Memorandum

Subject: **Revised** Lawrence Airport (LWC), Lawrence, KS. Parachute Landing Area Assessment

This is a revision to the previous Memorandum for Lawrence Airport dated December 28, 2016 as a result of updated parachute landing area information.

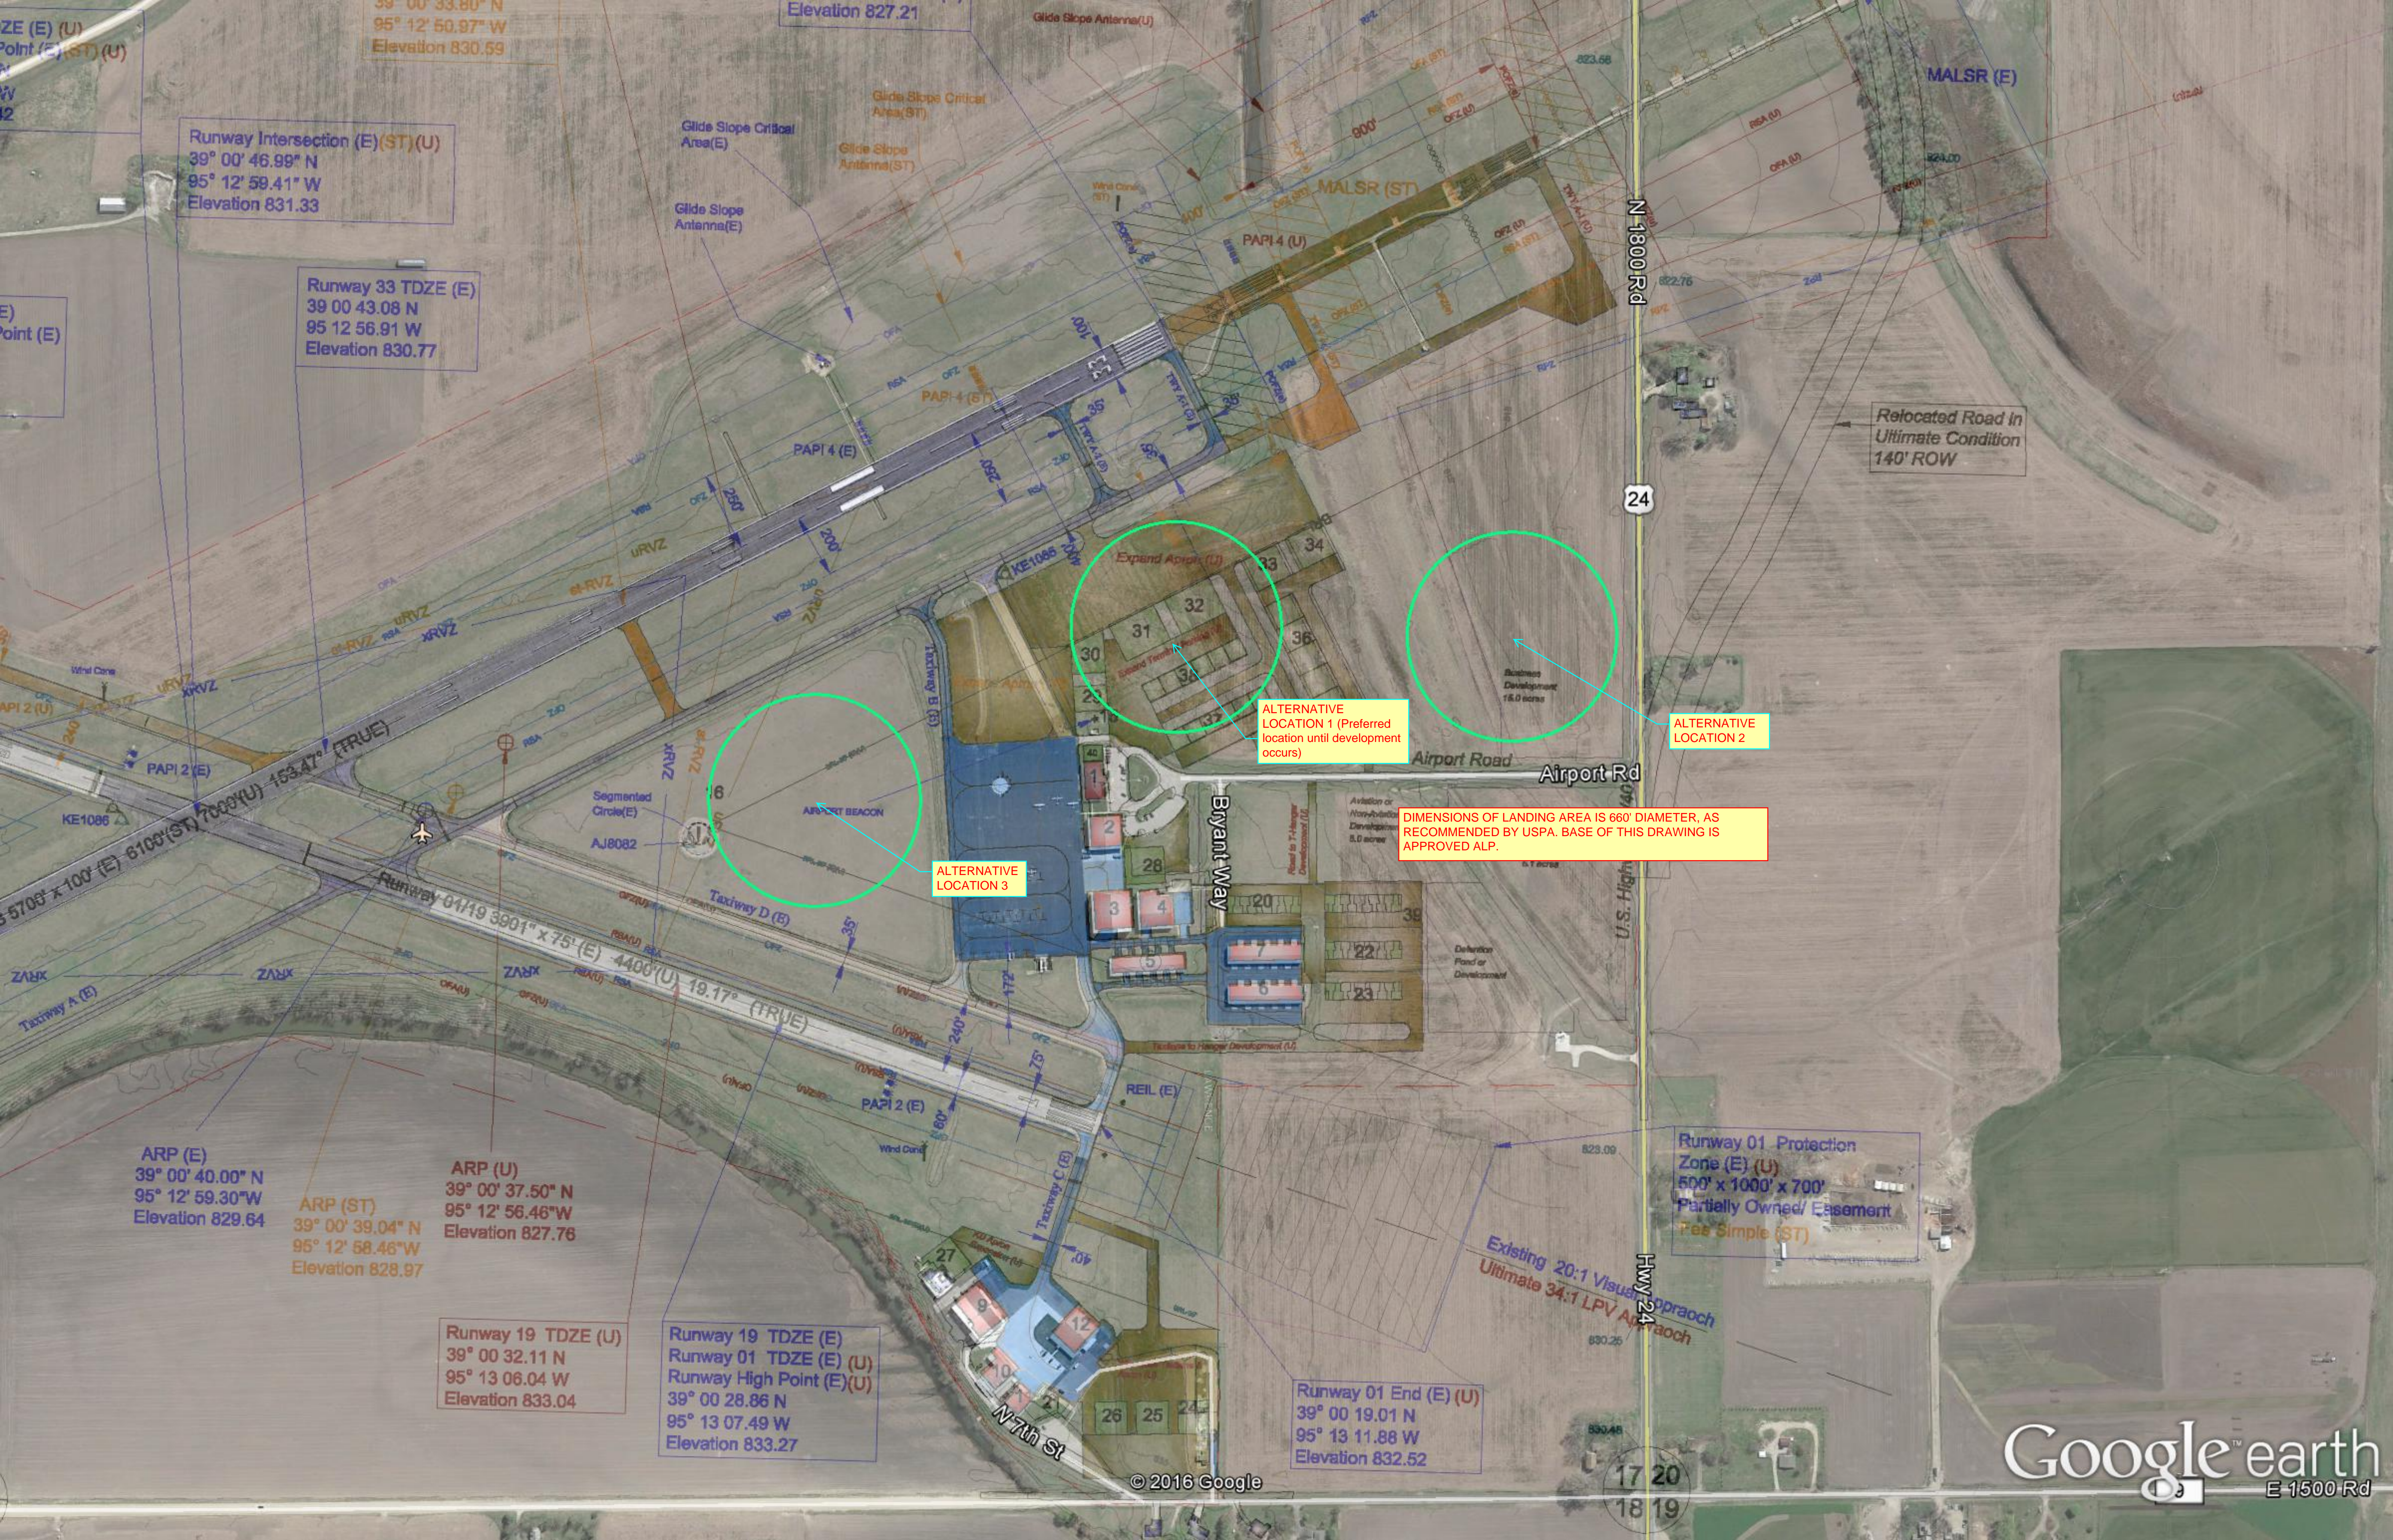
Upon review of the information gathered during the desk audit assessment, it is determined that all three (3) of the proposed parachute landing areas will accommodate US Parachute Association student, A, B, C, and D license holders, and Tandem parachute operations.

Utilizing any of the three proposed parachute landing area's provides risk mitigation by placing approximately four tenths (.4) of a mile between the parachute landing area and the airports life flight helicopter operation based on the airport. The size of the proposed landing areas can accommodate US Parachute Association student through D license holders, and Tandem parachute operations, with additional space beyond the 660' diameter in some areas. Additional risk mitigation will be established by developing a plan to incorporate the provision established by the Wichita FSDO safety review.

ALTERNATIVE LOCATION 1 (Preferred location until development occurs)

DIMENSIONS OF LANDING AREA IS 660' DIAMETER, AS RECOMMENDED BY USPA. BASE OF THIS DRAWING IS APPROVED ALP.

As previously identified during the Wichita Flight Standards District Office (FSDO) safety review on February 3, 2010, skydive operations can be supported on the airport provided certain provisions are met (see attached). A plan needs to be developed to implement the identified provisions before operations begin.
